Z-116
(2016)

PRELIMINARY SITE PLAN
BISHOP LAKE RD. SITE
Cobb County, Georgia
St. Clair Holdings

PETITION NO: Z-116

ZONING COMMENTS:

L-001
Sheet Number

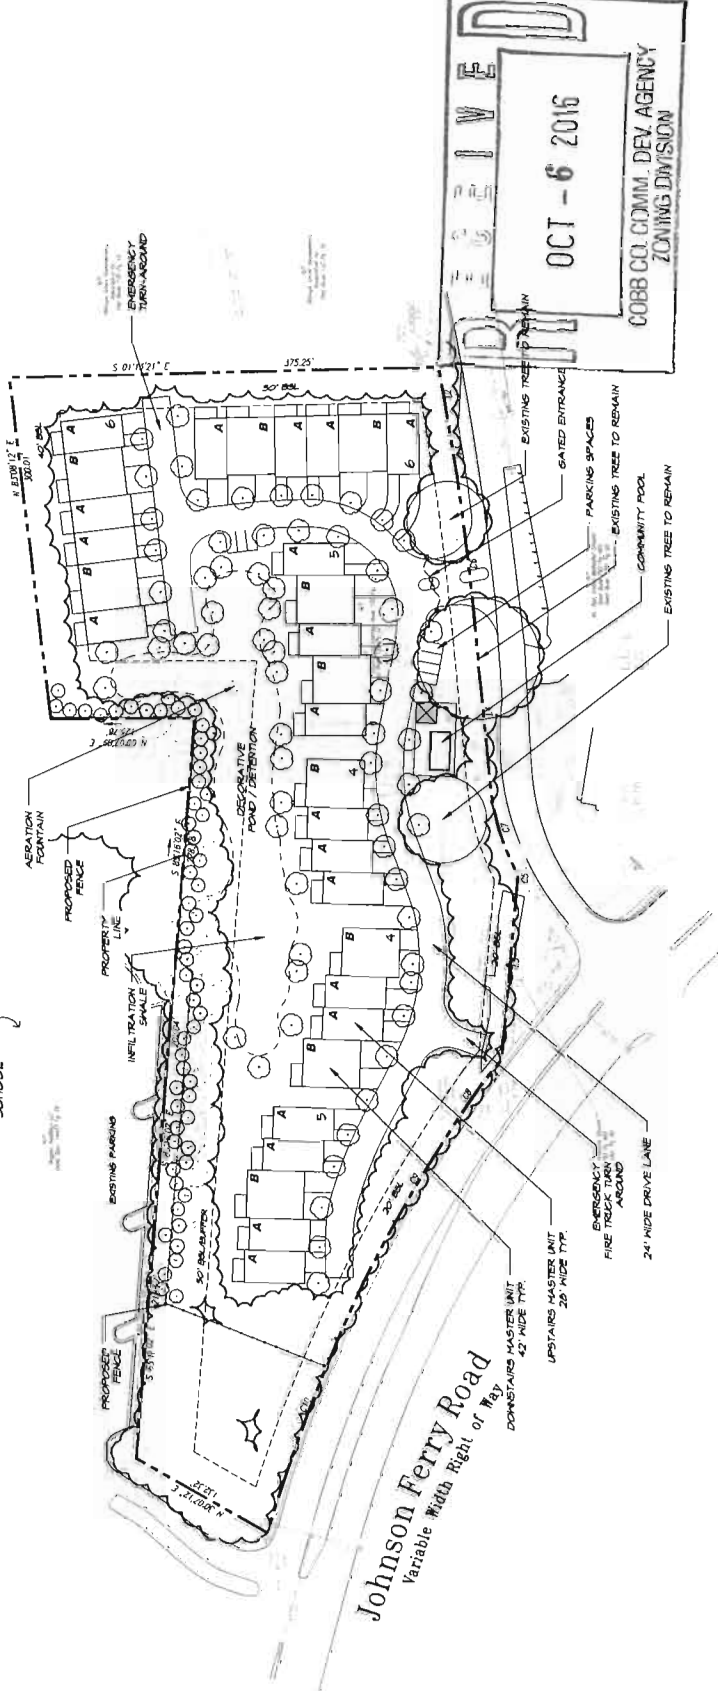
The proposed site plan will require a contemporaneous variance to allow five- and six-unit attached buildings instead of the four-unit maximum permitted by the RSL (non-supportive) district.

This project must comply with the Cobb County Tree Ordinance. The three existing trees shown as to remain will not receive Tree Ordinance density credit if there is any disturbance within their critical rootzones (CRZ). In addition, Tree Ordinance mitigation will be required if there is any disturbance within their CRZ and they meet the specimen tree criteria as per the Cobb County Tree Ordinance.

If a landscape buffer is required along the NE property line, then it must be fully vegetated across their entire width, and not include any deck/patio encroachments. The rear walls of the units along the NE property line are depicted as being congruent with the 40' building setback line, with no buffer being shown. For safety, security, and maintenance purposes, there must be a physical separation between the rear walls of these units and any required buffer.
